Addendum No. 1

City of Coquitlam
Tender 81293

Oakdale Park Stormwater Treatment Facility

Issue Date: April 9, 2024
(Consists of 34 Pages)

DETAIL #C: PROP. MH D04

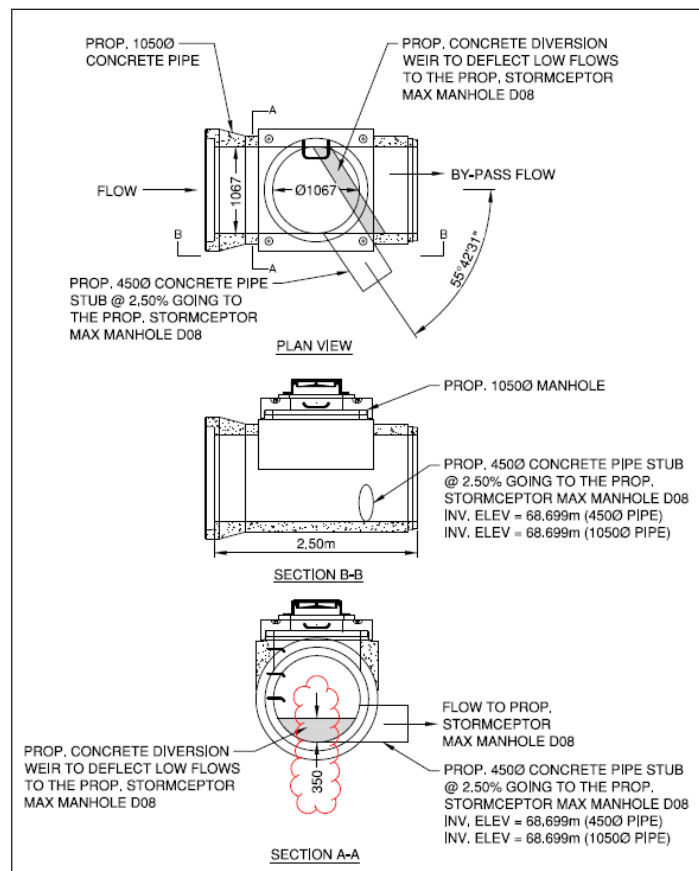
5. **Refer to:** Contract Drawings – Issued for Tender Drawings, Sheet 04 of 04.

AMEND: DETAIL #C: PROP. MH D04

Replace with: DETAIL #C: PROP. MH D04

Note: Concrete diversion weir height amended from 300mm to 350mm. As noted in the Contract Drawings, the Contractor is responsible for providing signed and sealed Engineered shop drawings for EoR approval, showing any required rebar or dowel reinforcement as necessary.

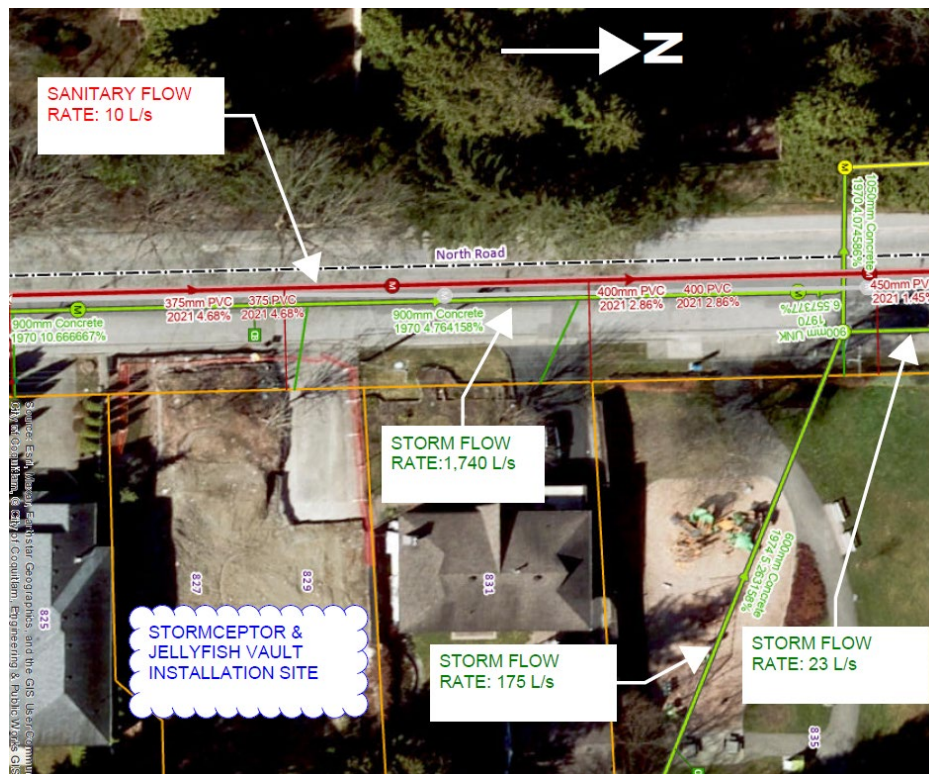
- A6) **Refer to Temporary Water Cap Detail on Sheet 02 of 04 in Contract Drawings.**
- Q7) After a review of the as-builts in that area, we are unable to confirm if the existing C900 sanitary main is restrained, can the City of Coquitlam please confirm. Also, please provide the flow rates at the existing storm pipes.

- A7) **The existing sanitary main main is not restrained. The Contractor is responsible for providing sufficient bypass pumping based on site conditions.**

Refer to below figure for estimated flow rates based on modelled data. Flow rates shown are maximum flow rates based on 5-year 24-hour I&I rainfall event for the sanitary main, and 10-year return 1 hour event for the storm mains. Note that construction for this project is scheduled for July to August (dry weather season).

STORMCEPTOR MAX 4713 to
JELLYFISH FILTER JFVLN-IV

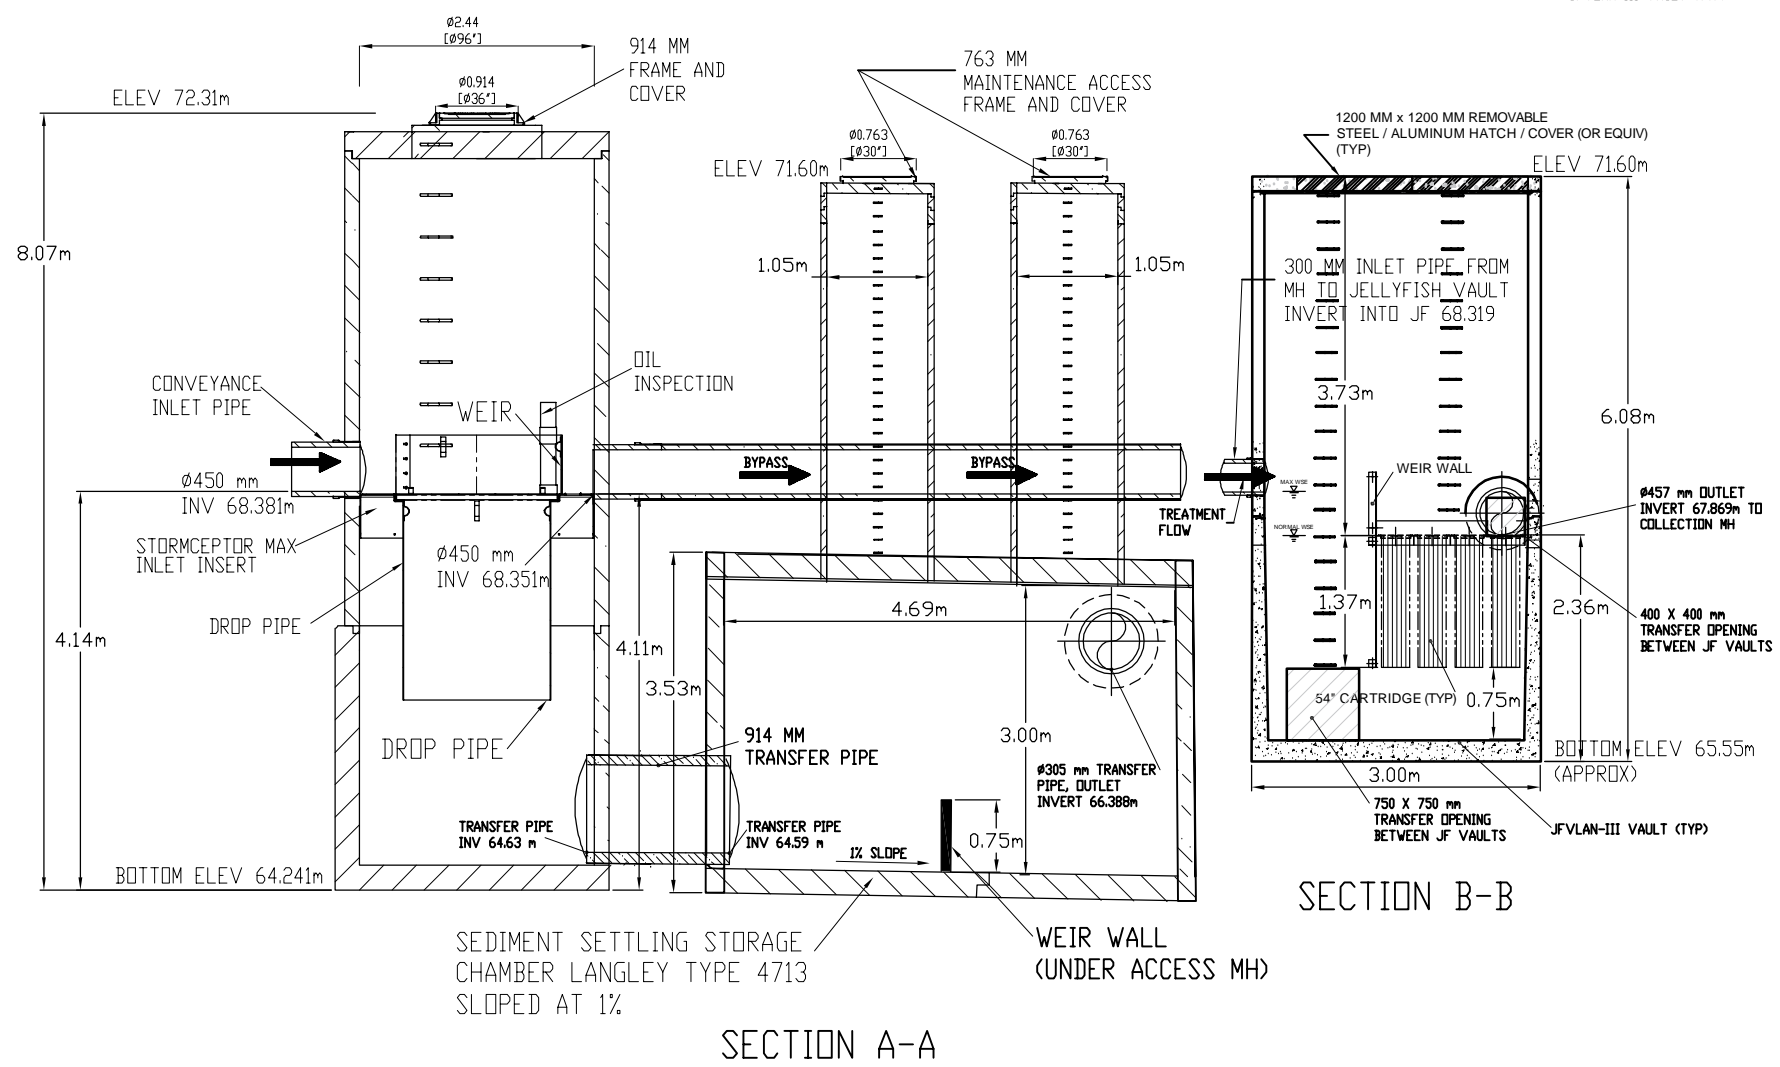
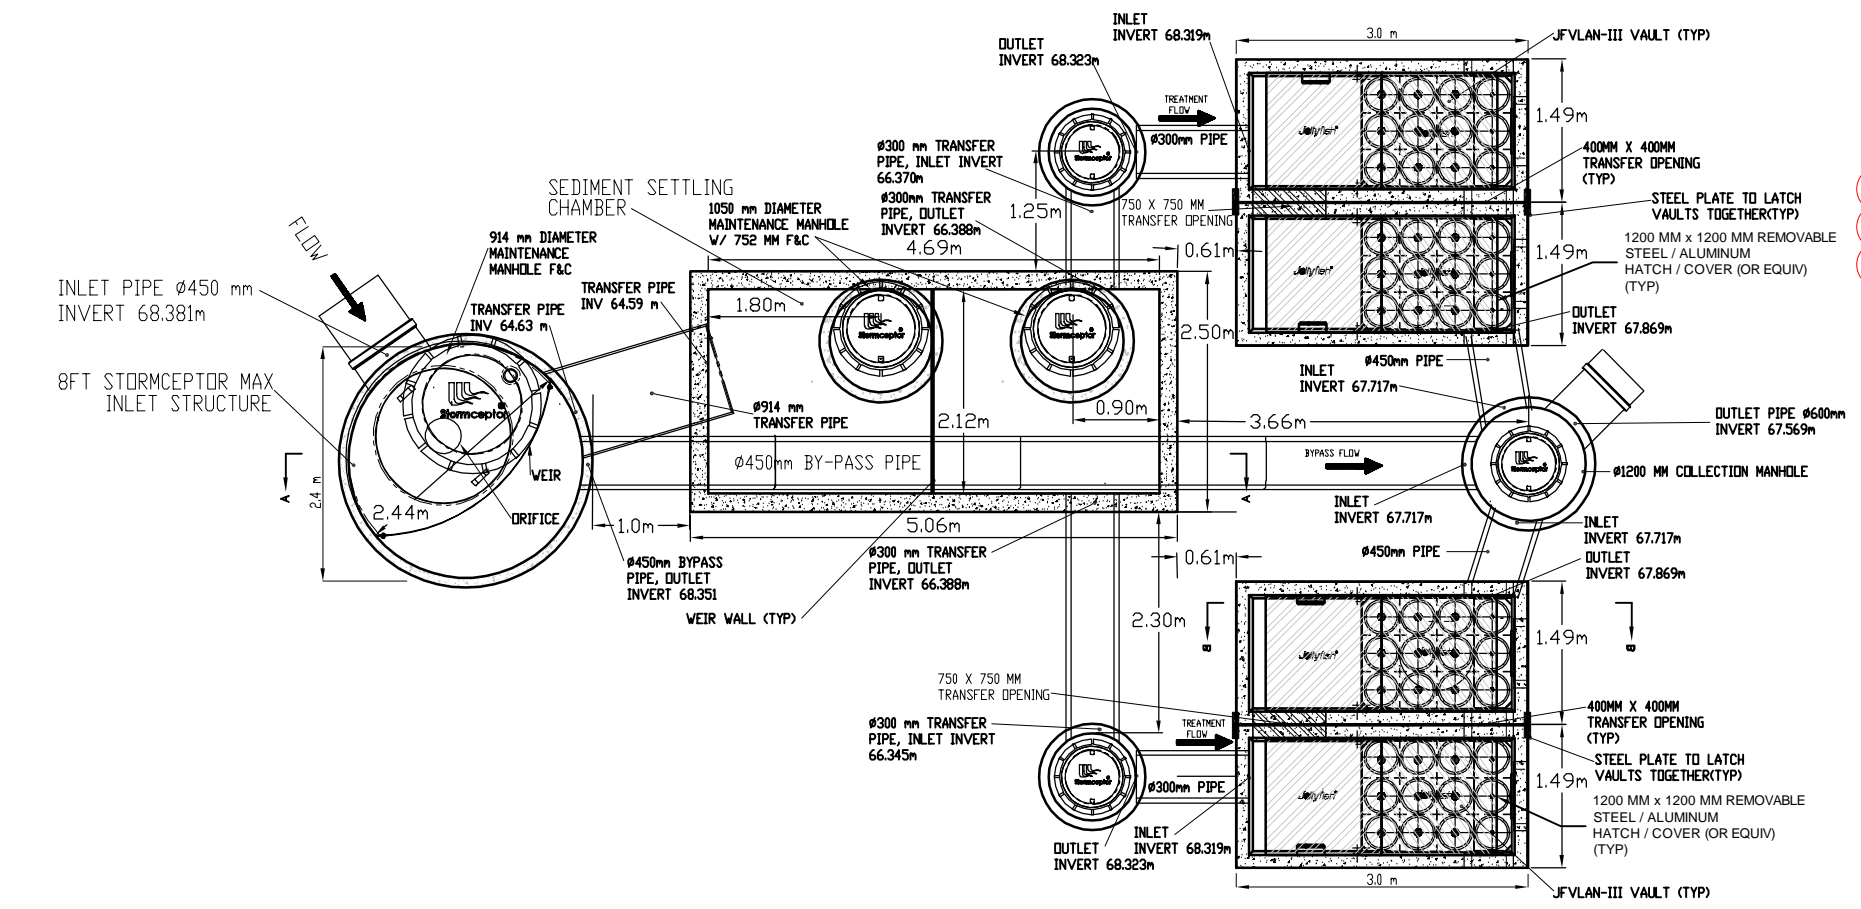
3. Refer to: APPENDIX B – Imbrium Systems Proposal Drawings & Specifications

DELETE: Page ISPD 1 “Imbrium Proposal Drawing”

REPLACE with: Page ADD 1 - 9 “Imbrium Proposal Drawing – Revision No. 1”

BUOYANCY COUNTER MEASURES

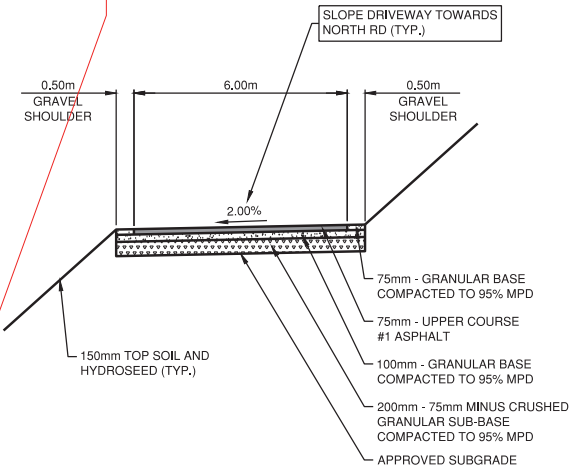
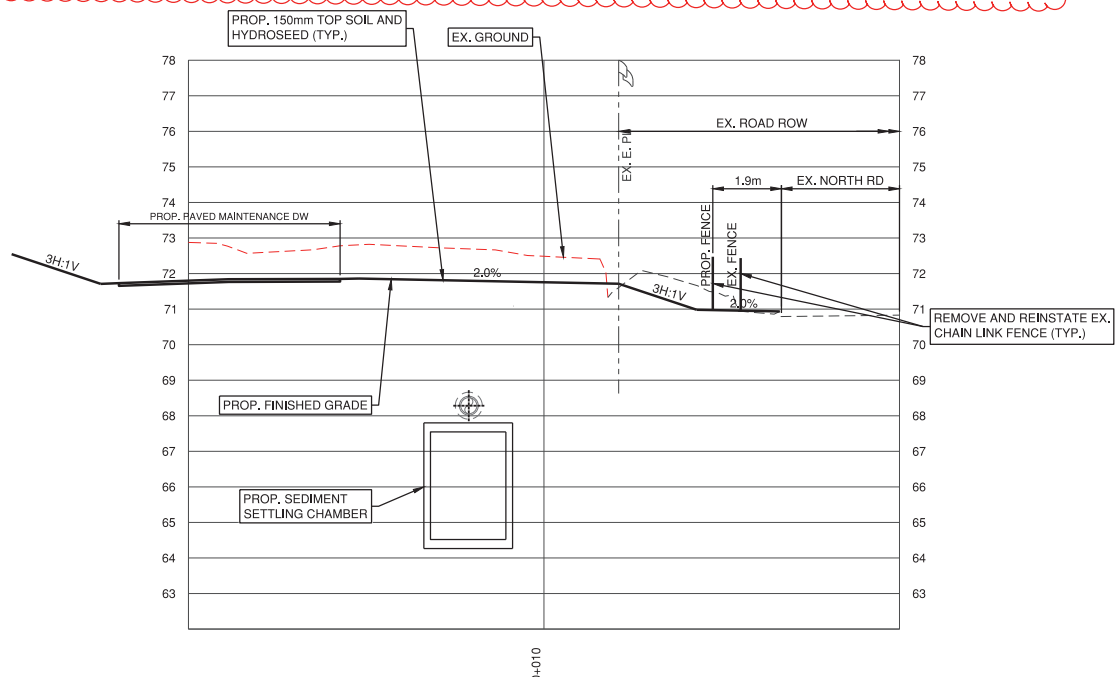
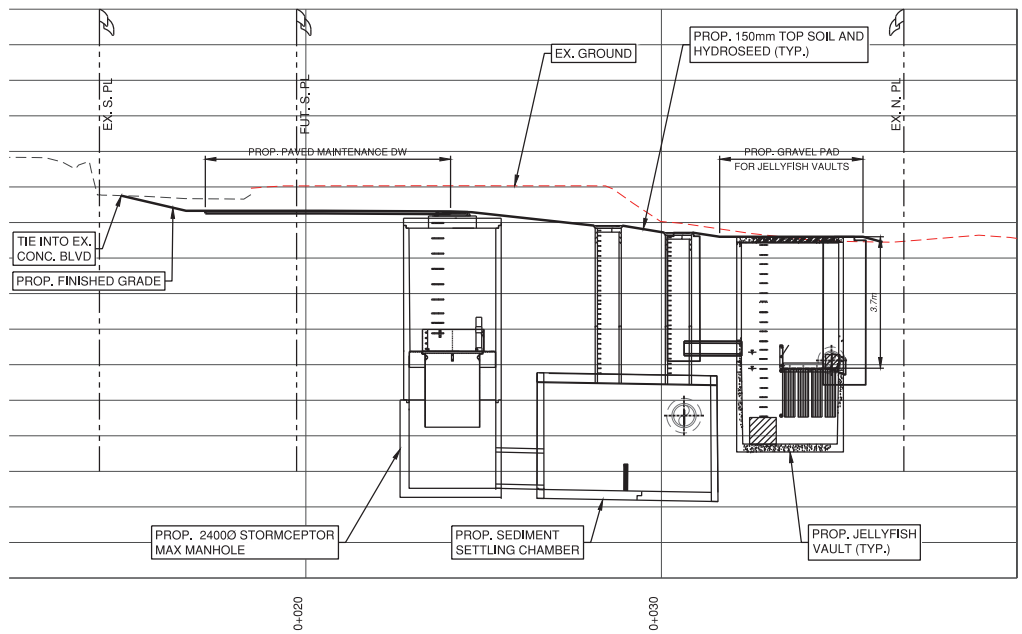
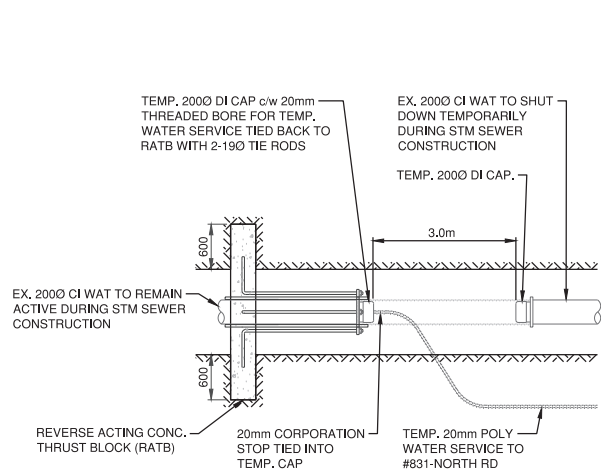
4. ADD: Appendix D – Kontur Draft Geotechnical Report & Buoyancy Counter-Measure Notes

STORM WATER TREATMENT FACILITY NOTES:

- 1) THE STORM WATER TREATMENT FACILITY STRUCTURES SHALL BE INSTALLED AND DESIGNED AS PER THE RECOMMENDATIONS OF KONTUR GEOTECHNICAL CONSULTANTS REPORT.
- 2) THE STORM WATER TREATMENT FACILITY STRUCTURES SHALL BE DESIGNED FOR THE GROUND COVER SHOWN ALONG WITH H2O LOADING AND FULL HYDROSTATIC PRESSURE, ASSUMING THE WATER LEVEL MAY RISE TO GROUND SURFACE.
- 3) THE GROUNDWATER LEVEL IS EXPECTED TO BE ABOVE THE FOUNDATION LEVEL OF THE PROPOSED STRUCTURE. AS SUCH, THE STORM WATER TREATMENT FACILITY STRUCTURES SHALL BE DESIGNED FOR BOUYANCY.

Minimum Base Dimensions required to counter act Bouyancy

Storm Water Treatment Structure	Additional base thickness (m)	Extended base dimension past Manholes outside wall (m)
2400mm dia. Stormceptor MH D08	N/A	0.152
Sediment Settling Storage Chamber	N/A	N/A
900mm diameter Manhole	0.30	N/A
JellyFish Vault	0.70	N/A
1200mm diameter Manhole D09	0.30	N/A
